Sub: Diversion of 87.5709 Ha. reserved & Protected Forest land for 4 laning of Indore-Muktainagar section of NH-753L from Boregaon Buzurg, Khandwa District in MP Design Ch. 139+000 to Muktainagar Ch. 216+278 (length 77.278 Km) under Bharatmala Pariyojana in Khandwa and Burhanpur District of Madhya Pradesh- Proposal no. (FP/MP/ROAD/156438/2022)-**Compliance of observations raised by REC Committee-Reg.**

SUB: -- REPORT ON VETTING AND VERIFICATION OF THE COMPLIANCE REPORT SUBMITTED BY NHAI DPR CONSULTANT I.E. M/S RITES IN RESPECT OF OBSERVATIONS RAISED BY REGIONAL EMPOWERED COMMITTEE DURING MEETING DATED 23.10.2023 REGARDING RECTIFICATION IN THE ALIGNMENT TO AVOID FRAGMENTATION OF FOREST PATCHES FOR THE WORK OF 4-LANNING OF BOREGAON BUZURG TO MUKTAINAGAR SECTION OF NH-753L IN THE STATE OF MADHYA PRADESH.

Subject: Consultancy Services for preparation of DPR for Development of Green field Stretches for improving direct connectivity in Indian Cities (Lot-8/Package 2) [Gadchiroli – Karimnagar (215 km) and Khandwa – Akola (140 km)] – **Compliance of Observation raised by R.E.C committee for Forest Diversion proposal no. FP/MP/ROAD/156438/2022-reg.**

The tentative vertical schematic is presented below, if we shift the alignment to the right side of the existing road

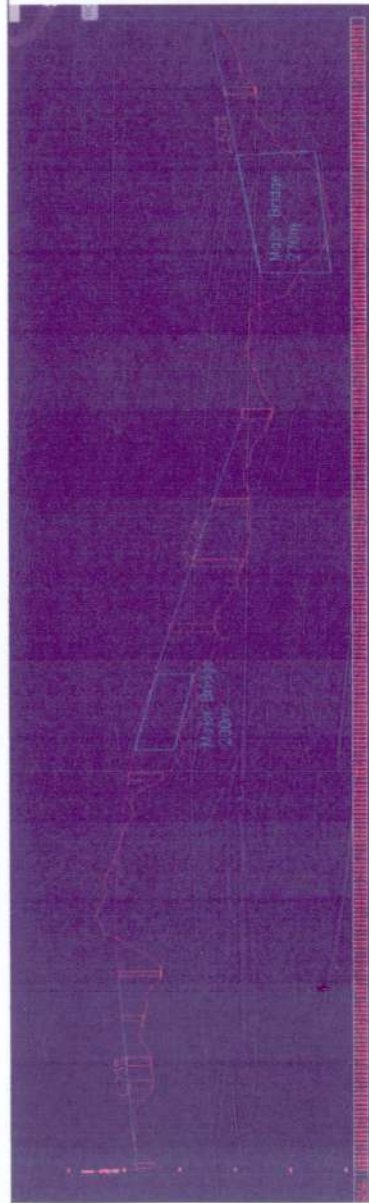
| Photos | Existing Road Alignment | Comments on Proposed Alignment | Reasons for not shifting the proposed alignment towards RHS of Existing Road | |
|--------|--|--------------------------------|---|----|
| |  | | <p>be constructed throughout the stream line resulting in extra cost of to the project.</p> <ul style="list-style-type: none">There are lot of small streams passes across the alignment which may result in construction of 11 culverts and 02-Major bridge (200m & 270m in length) making the project uneconomical.As per the above conditions, the shifting of approved alignment to the right side of the existing road is not feasible. | |
